# Access Compliance Report

## Public Rights-of-Way

### (Curb Ramps)

Intersection ID: 50241	Main Street: EVERGREEN TERRACE DR	Cross Street: CEDAR WALK LN	Location: NE
ADA ID: 0D29DDF4758D	Ramp Type: Perp	Initial Pass/Fail: Fail	Overall Compliance: No
Severity Score: 12.5			
Codes/Mitigation Info/Possible Solution		Field Measurements/Component Compliance

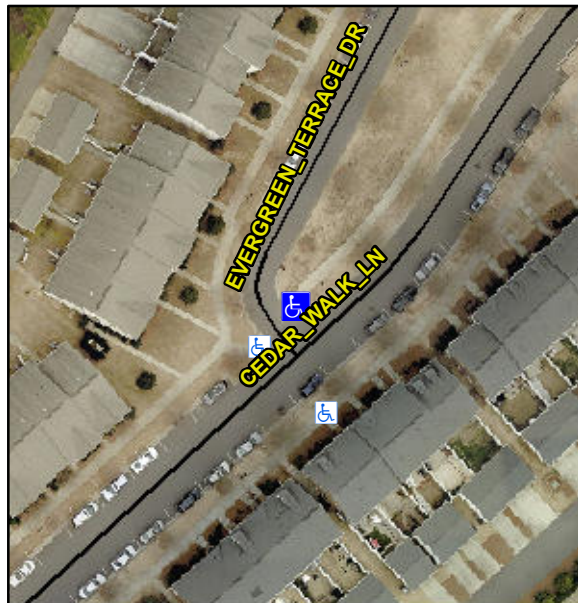
**Not Found, R304.2.2**

Compliance	Description	Data	Compliance	Description	Data
N/A	Ramp Length (in)	70.5	No	Ramp Slope (%)	10.2
Yes	Ramp Width (in)	48.5	Yes	Ramp XSlope (%)	0.2
N/A	Flare Type LT	N/A	N/A	Flare Type RT	N/A
N/A	Flare Slope LT (%)	N/A	N/A	Flare Slope RT (%)	N/A
N/A	Flare Traversable LT?	N/A	N/A	Flare Traversable RT?	N/A
N/A	Landing Length (in)	N/A	N/A	DWS Provided?	N/A
N/A	Landing Width (in)	N/A	N/A	DWS Contrast?	N/A
N/A	Landing Slope (%)	N/A	N/A	DWS Length (in)	N/A
N/A	Landing X Slope (%)	N/A	N/A	DWS Full Width?	N/A
N/A	Landing Curb? (Y/N)	N/A	N/A	DWS Offset (in)	N/A
N/A	Shared Landing?	N/A			
N/A	Gutter Ponding?	N/A	N/A	Gutter Slope (%)	N/A
N/A	Gutter Lip Ht (in)	N/A	N/A	Gutter X Slope (%)	N/A
N/A	Painted X Walk1?	No	N/A	Painted X Walk2?	N/A
	X Walk 1 Direction	To SW		X Walk 2 Direction	N/A
N/A	X Walk 1 Width (in)	N/A	N/A	X Walk 2 Width (in)	N/A
	X Walk 1 Slope (%)	0.1		X Walk 2 Slope (%)	N/A
	X Walk 1 X Slope (%)	0.1		X Walk 2 X Slope (%)	N/A

**Remove & Replace Entire Ramp.**
